Liberty School District – Baseball Sotball Complex
Addendum No: 004
Description Narrative
August 04, 2023

ADDENDUM NO. 04

Project: LHS/LNHS Baseball and Softball Field Upgrades

Project No. 23023/23047

A1 | Scale 3/8" = 1'-0" | North Dugout Foundation Plan

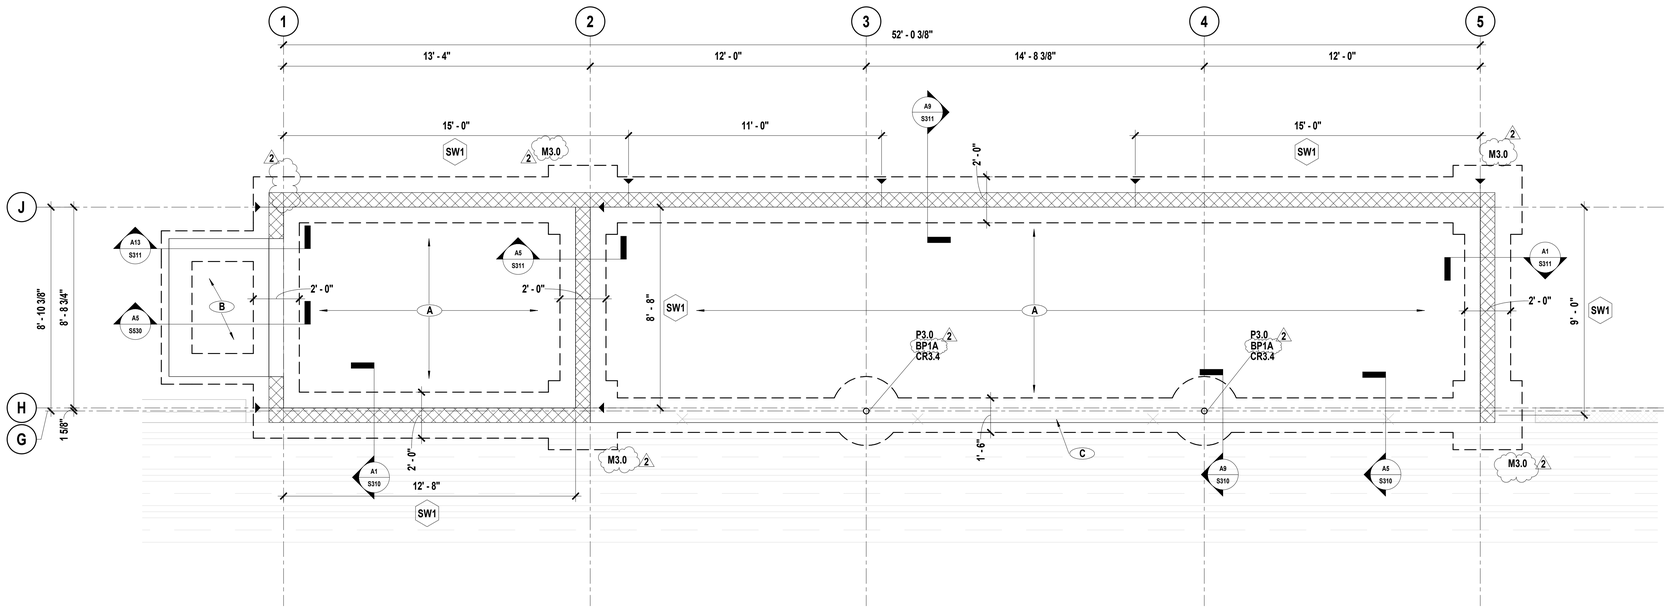
S5.1 ADD M3.0 footings at ends of 9'-0" shear walls on A1/S400 and REVISE foundation schedule.

S5.2 REVISE base plate callouts at CR3.4 on A1/S400 to read the following: "BP1A" and REVISE base plate schedule.

A11 Scale 3/8" = 1'-0" — Alternate Foundation Plan - Scorer's Box — NORTH

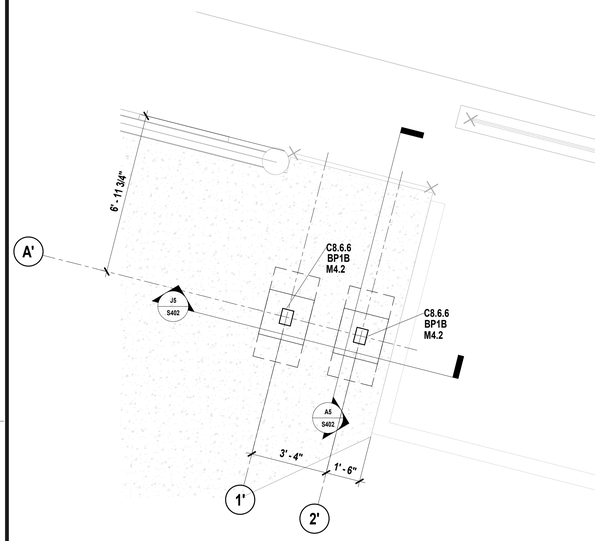
S2.4 ADD callout A11/S402 at scorer's box alternate.

S7.1 ADD sheet with Alternate foundation and framing plans and details.

N9 Scale 3/4" = 1'-0" — Typical Tension Backstop Netting Footing

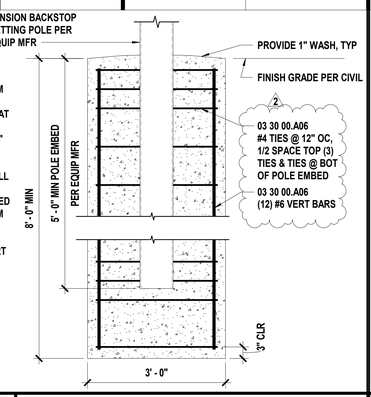
S8.3 REVISE reinforcement steel sizes on N9/S530 per manufacturer details.

N13 Scale NTS — Typical Foul Pole Footing

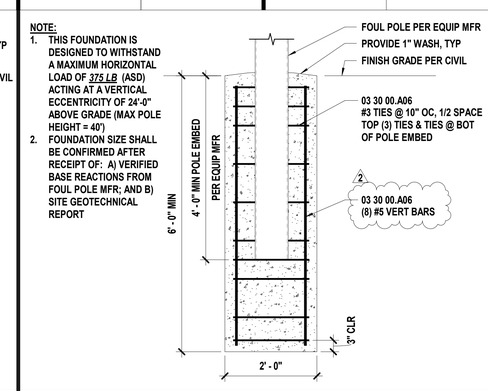
S8.4 REVISE reinforcement steel sizes on N13/S530 per manufacturer details.

J9 Scale 3/4" = 1'-0" — Typical Batting Tunnel Footing

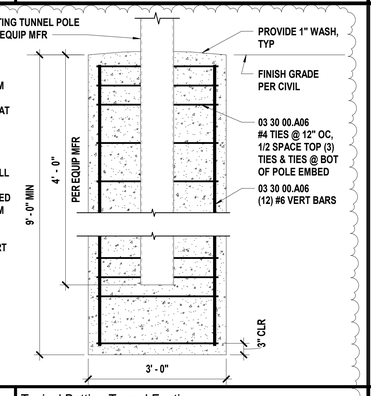
S8.2 ADD J9/S530: Typical Batting Tunnel Footing.

J9 Scale 3/4" = 1'-0" — Typical Wood Beam Bearing Parallel to Masonry Wall

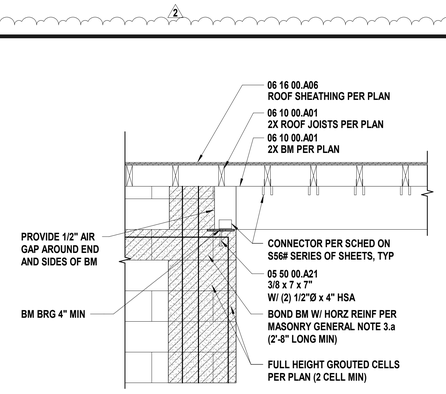
S10.1 ADD detail J9/S541: Typical Wood Beam Bearing Parallel to Masonry Wall.

A7 Scale 1/16" = 1'-0" — Field Level - Softball

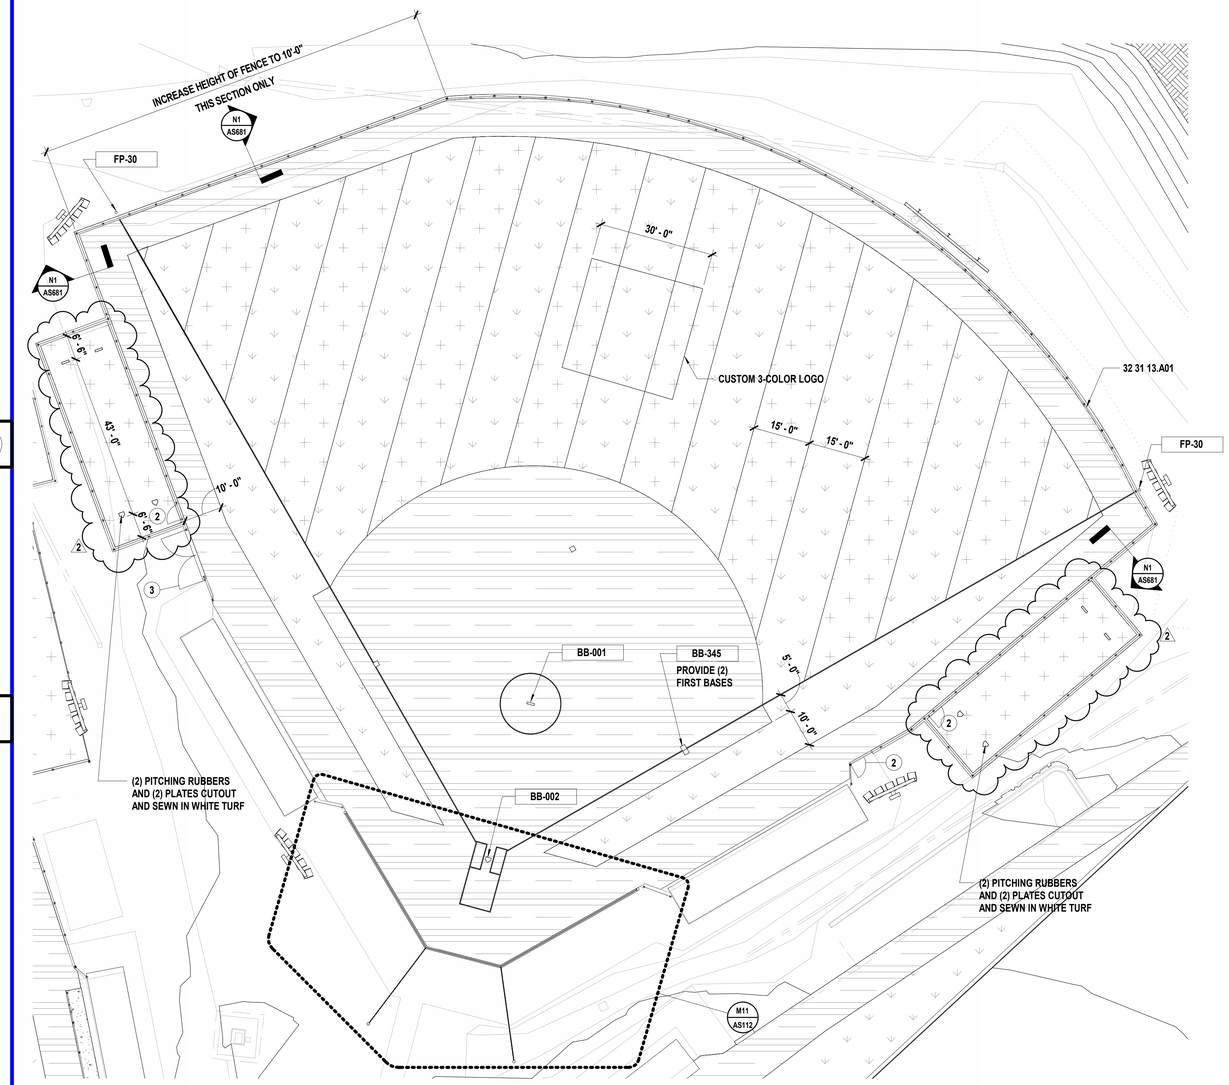
A13.1 ADD 3'-0" in length (towards home plate) to 3rd base both bullpens. REVISE gate access to both bullpens and ADD dimensions for recommended placement of sewn in home plate at pitching rubber. Find these changes as clouded on drawing A7 on re-issued sheet AS112.

A1 Scale 3/16" = 1'-0" — Dugout Scorer's Box Retrofit (Alternate No. 3)

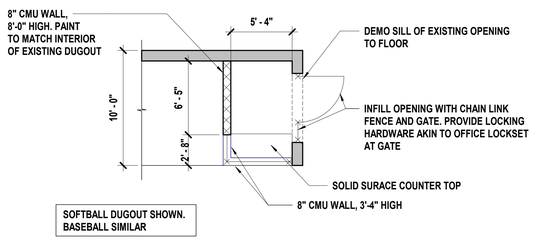
A14.3 ADD "(Alternate No. 3)" to description of drawing A1.

A6 Scale 1/32" = 1'-0" — Perimeter Concrete Turf Curb

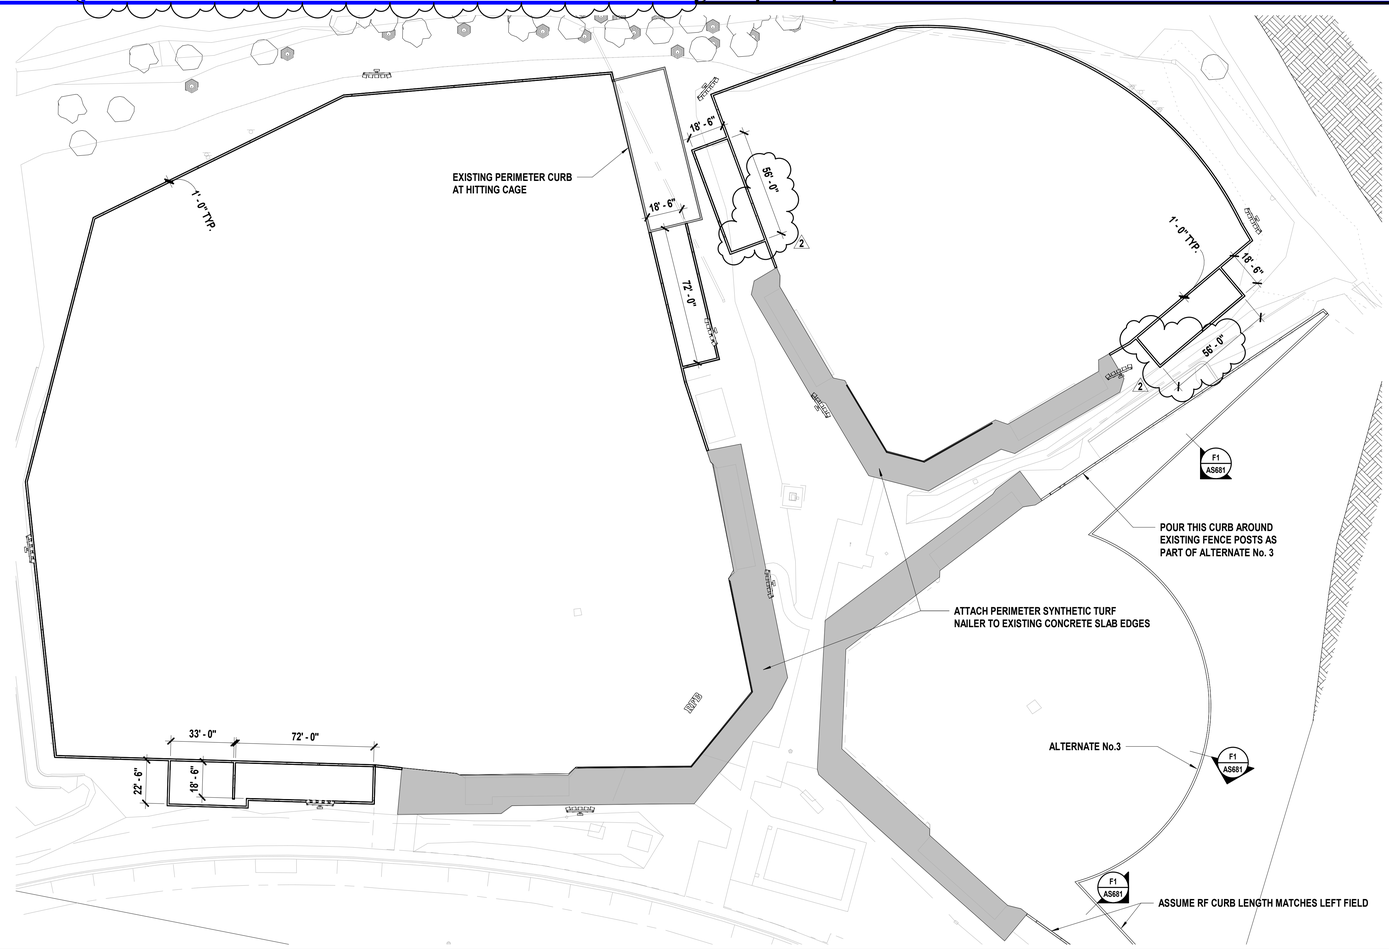
A14.4 REVISE curb dimensions on Drawing A6 that coordinate with the enlarged bullpens
